TECHNICAL MEMORANDUM

Date: June 12, 2025

Project: Lower Kittitas Floodplain Reconnection Project

Re: Recommended Concept Design Revisions

Figure 2. Overview sheet from the USBR Concept designs (2024).

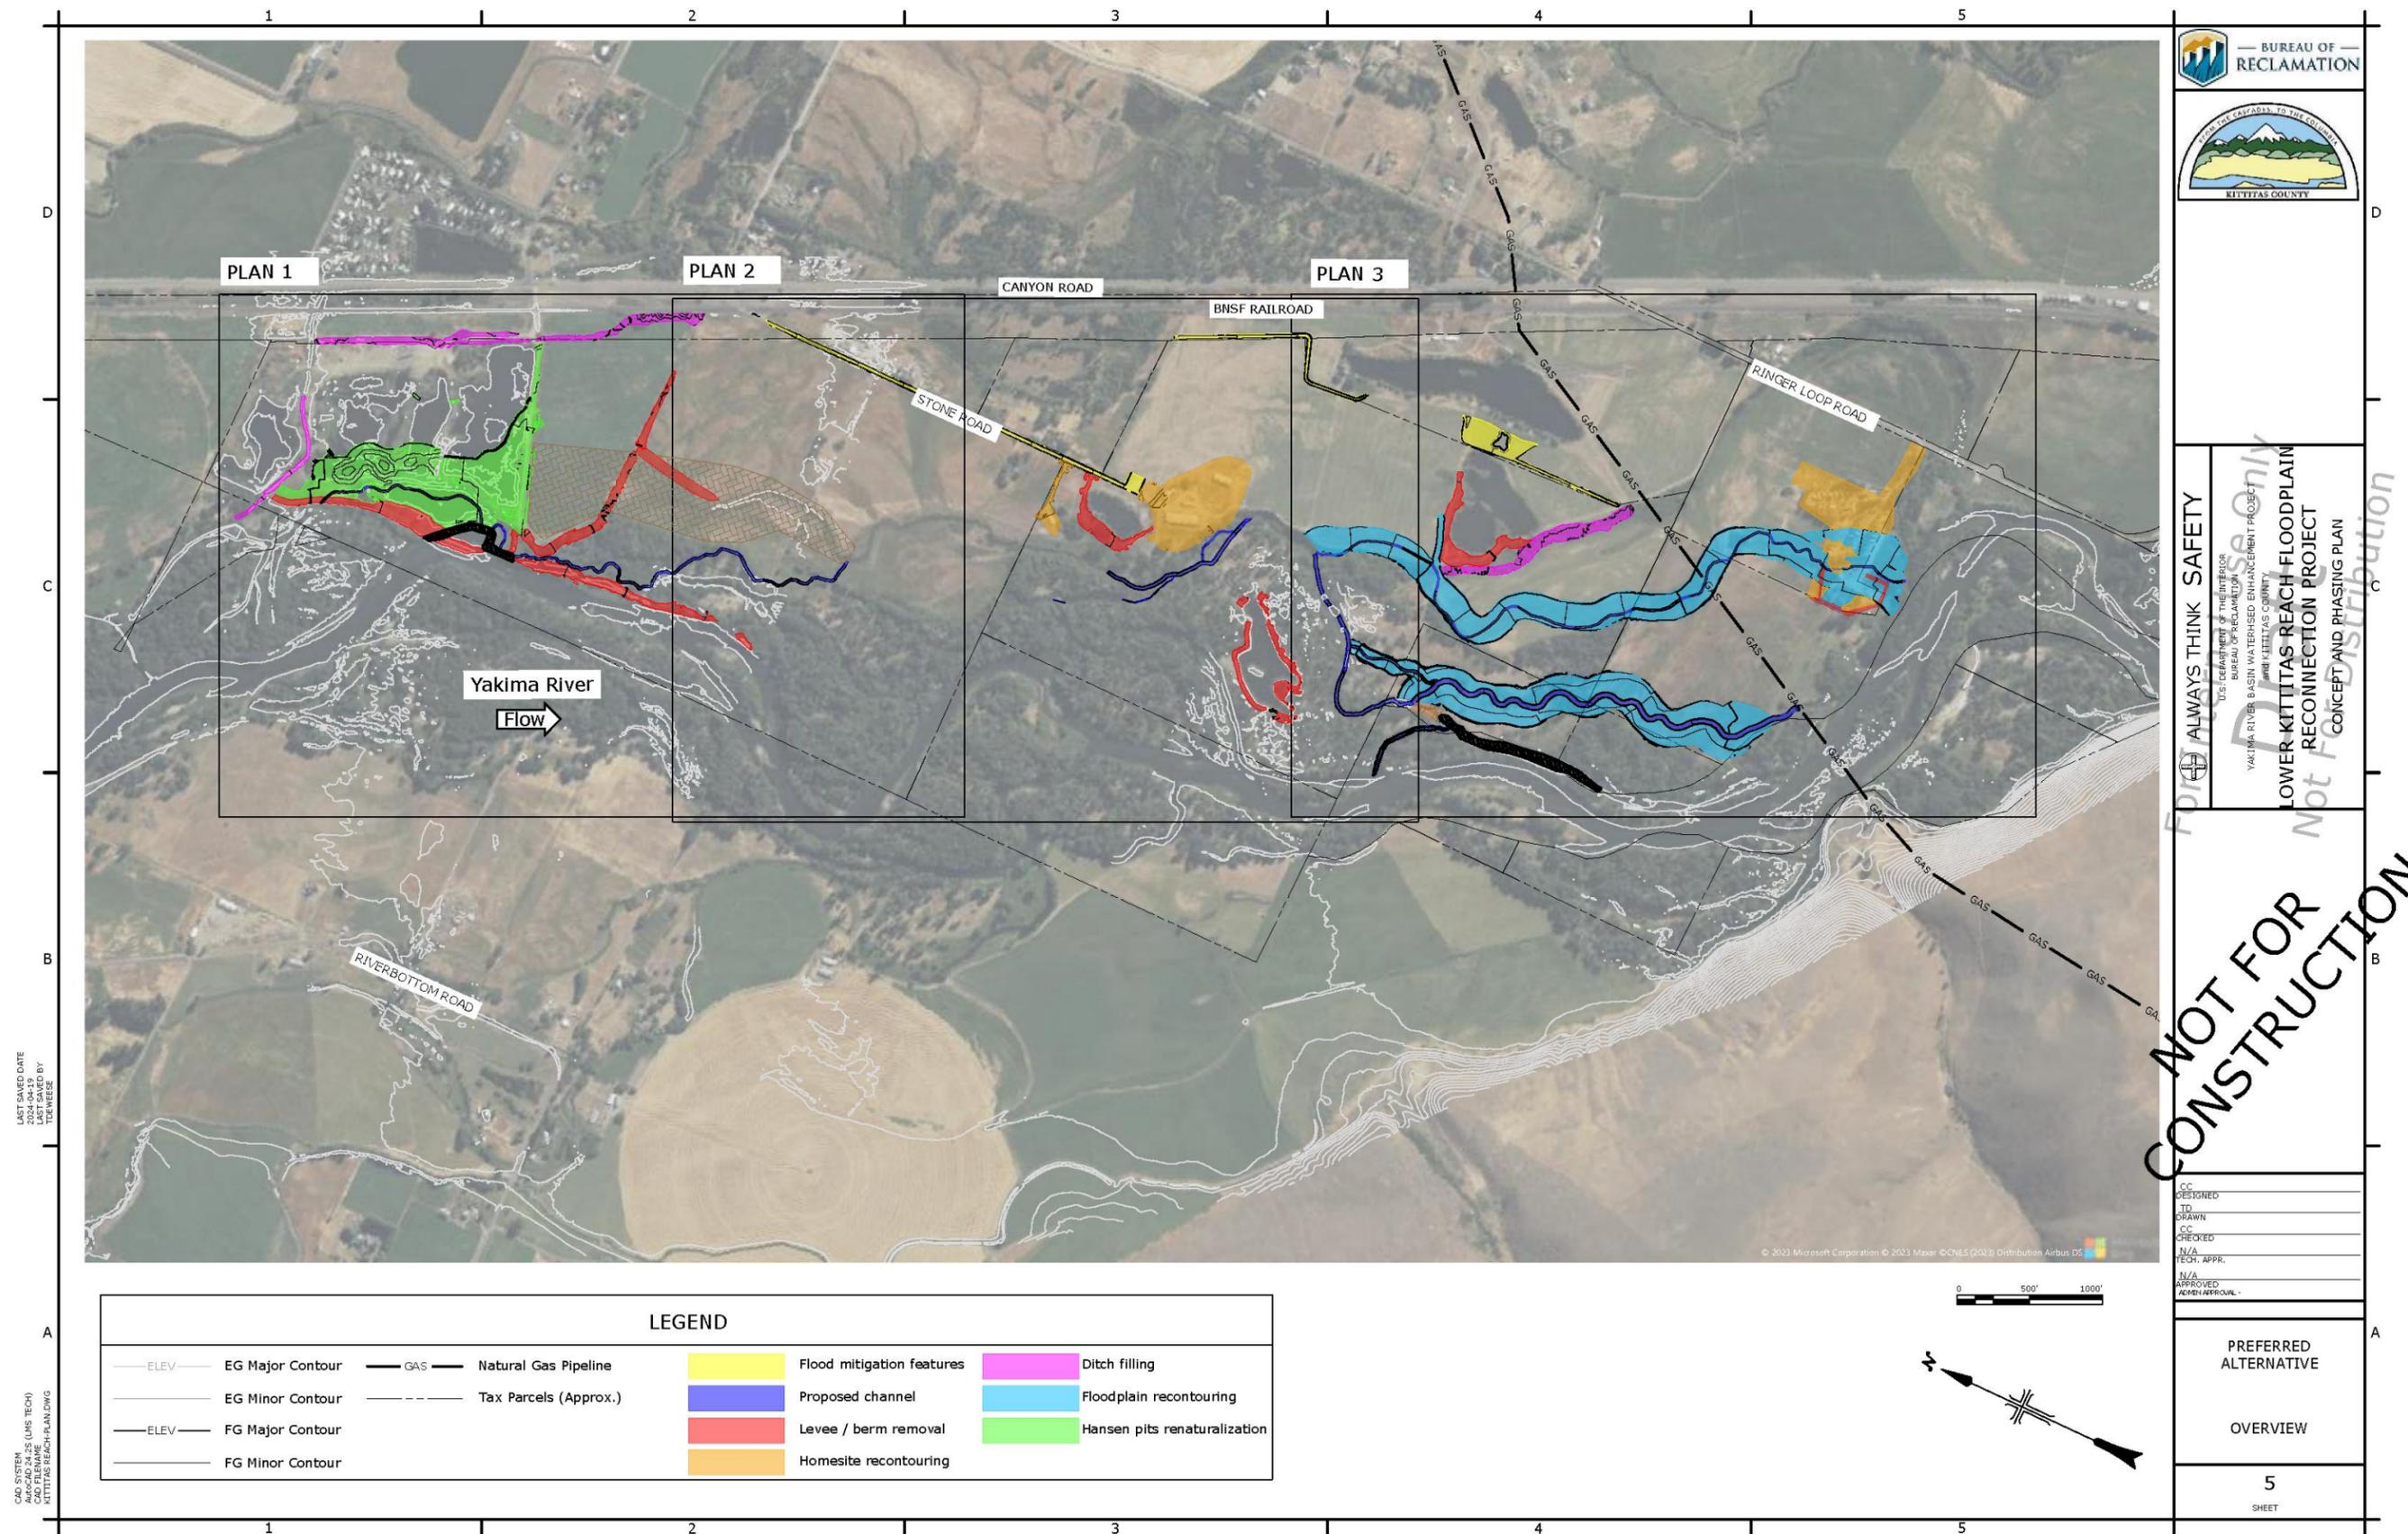
The 2024 Reclamation conceptual designs (Figure 2) include numerous actions that achieve the project objectives and satisfy constraints. The major conceptual design elements include the following:

- Excavation and removal of existing levees and berms
- Flood mitigation features
- Removal of headgate structures
- Partially fill Hansen Pits
- Floodplain recontouring for connection at 1.5-year flood events
- New side channels and side channel connections
- Restoration of former homesites

These proposed design elements enhance the connection between the Yakima River and its adjacent floodplain, restoring more natural flood dynamics and improving key floodplain processes such as surface disturbance, juvenile fish habitat access, and side channel evolution. The designs align well with the proposed land uses, balancing habitat restoration, recreation, agriculture, and private land considerations. An overview sheet of these concept designs is attached below.

Figure 3. Visualization of design modifications being considered by the project team.

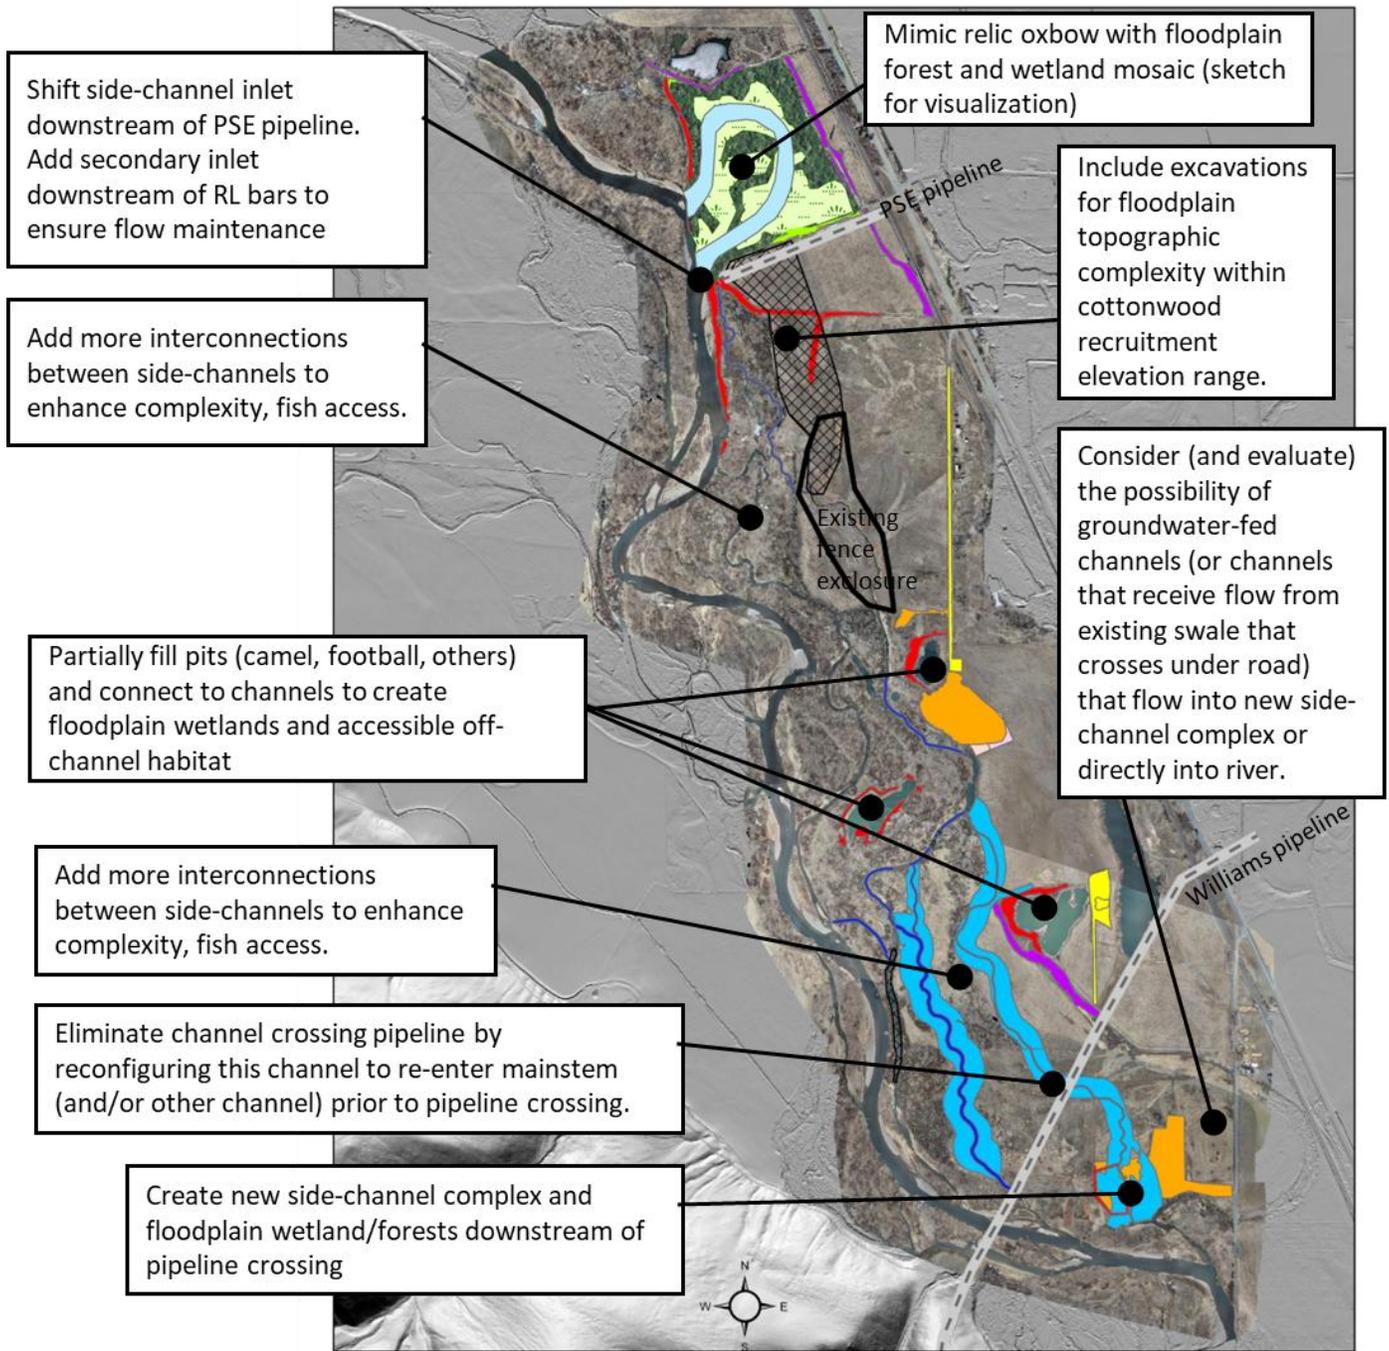
Evaluate potential for the removal of the downstream end of the Jeffries levee across the mainstem Yakima.

Proposed Modification: Modify existing and perform *additional* excavation for floodplain topography within cottonwood recruitment elevation range. Create floodplain topographic complexity and target floodplain elevations in select areas to align with conditions that can support cottonwood seed dispersal and establishment. This complexity may take the form of floodplain wetlands and alcoves connected to new or existing channels, strategically graded to promote variable inundation thresholds.

Proposed Modification: Modify the proposed side channel inlet location downstream of the PSE pipeline to reduce interaction with infrastructure. A secondary inlet may be created downstream of river-left bars to support flow into the side channel under varying river conditions.

Proposed Modification: Construct additional connections between side channels to allow for greater hydrologic diversity. The exact configuration of these interconnections could take on numerous forms and patterns.

Proposed Modification: Redirect the currently proposed side channels to re-enter the mainstem or another side channel before reaching the Williams pipeline.

Proposed Modification: Develop a side channel network and associated floodplain wetland and forest features in the floodplain downstream of the Williams pipeline crossing.

Proposed Modification: Assess the feasibility of incorporating groundwater-fed channels, informed by recently collected groundwater data, to enhance floodplain connectivity and habitat complexity.

Proposed Modification: Adjust floodplain elevations and fill portions of the Hansen Pits in upper region of project site to reflect a historical oxbow feature, incorporating a mix of forested and wetland areas, while keeping the most northern pit available for recreational use.

Proposed Modification: Modify or partially fill select ponds (including Camel, Football, Baseball, and Guinea Pig) and establish hydrologic connections to existing or new channels where feasible.

Removing a portion of this levee could open floodplain and side-channel connectivity. This modification would likely increase inundation on the river right, while easing pressure of erosion on the Hansen ponds. This modification and additional alternatives has yet to be thoroughly evaluated due to feasibility of landowner cooperation remaining uncertain.

Rationale: This modification more broadly applies the recontouring actions of conceptual design element 3 to the entire project site. It also highlights some alterations to the recontouring locations to avoid the Williams Pipeline alignment. After design team meetings and examination of the existing surface post additional survey data collection, it was made clear that there are some additional opportunities to target cottonwood recruitment elevations by expanding the recontouring actions beyond just the southern portion of the project. This would help achieve the objective of cottonwood gallery forest development throughout the whole floodplain. The expanded areas in the north would apply to the area in the concept plan identified for floodplain roughness (brown hatch on concept sheet) and possibly other nearby areas. In the south, the areas identified for recontouring would be modified to avoid the Williams Pipeline, and potentially increased in areal extent. Excavations would be preferentially associated with new side-channels (as before), but would have a different configuration due to realignment of the side-channels (see modifications under Design Element 5). The areal extent may be expanded to increase connectivity while also providing material for filling of additional pits (see modification under Design Element 7).

Rationale: With additional pipeline location information obtained through coordination with PSE and geotechnical survey updates, it became apparent that the side channel inlet should be moved downstream of the pipeline crossing. This adjustment maintains the function of the side channel

while avoiding the pipeline. Conceptual designs did not fully account for the subsurface depth and alignment of the PSE line, which has since been clarified through additional coordination. This modification can avoid interaction with infrastructure, help maintain more consistent flow into the side channel, reduce the likelihood of sediment deposition at the inlet, and provide additional aquatic habitat.

Rationale: The NHC geomorphic analysis supports multithreaded channels. This recommendation builds on survey data that clarified flow paths and identified areas where channel connections could improve floodplain activation and habitat complexity. Initial conceptual designs proposed limited channel interaction due to data gaps. This enhanced connectivity can improve the resiliency and persistence of surface water connections and fish passage. It also creates a more dynamic and complex aquatic environment, can provide more cottonwood recruitment opportunities, and supports water quality by increasing interaction between surface and groundwater.

Rationale: With additional pipeline location information and internal risk management discussions, it became clear that the originally proposed channel alignment will need to re-enter the mainstem upstream of where the pipeline crosses under the river. Adjusting the alignment upstream of the pipeline reduces the need for armoring or ongoing maintenance, while still achieving hydrologic reconnection. This can reduce maintenance concerns, limit potential interaction with the pipeline, and support channel stability while maintaining hydrologic function.

Rationale: This modification was developed after identifying constraints upstream due to pipeline alignment and cut-fill limitations. The design team identified downstream areas with favorable topography and hydrologic conditions for new channel and wetland development. This modification provides off-channel habitat and enhances floodplain connectivity in lieu of the previous channel and floodplain excavations that would have crossed over the pipeline.

Rationale: Site observations and groundwater monitoring stations both indicate areas of consistent groundwater expression that could support groundwater-fed channels. There is currently flow that is at least seasonally expressed in the channel that contributes to the abandoned oxbow that crosses Ringer Loop Road. If viable, tapping into this feature to feed a groundwater or high-flow surface water channel complex could provide cool-water habitat for fish, enhance seasonal flow variability, provide flood refuge habitat, and improve connectivity between wetlands and the river.

Rationale: Design team meeting conversations, informed by geomorphic analysis and a review of historical aerial imagery, led to the development of this idea to align with historical floodplain patterns and accommodate recreational use. This is likely to support native riparian vegetation including cottonwood seedbed establishment, enhance seasonal groundwater exchange, and offer rearing and refuge opportunities for fish and wildlife.

Rationale: This modification is supported by additional survey data and discussions with the design team on how to optimize accomplishing floodplain and off-channel objectives. These changes are aimed at improving floodplain connectivity, expanding wetland habitat, and creating off-channel features that may support fish, amphibians, and other wildlife. This is also expected to help with achieving an overall cut-fill balance for the project as a whole.
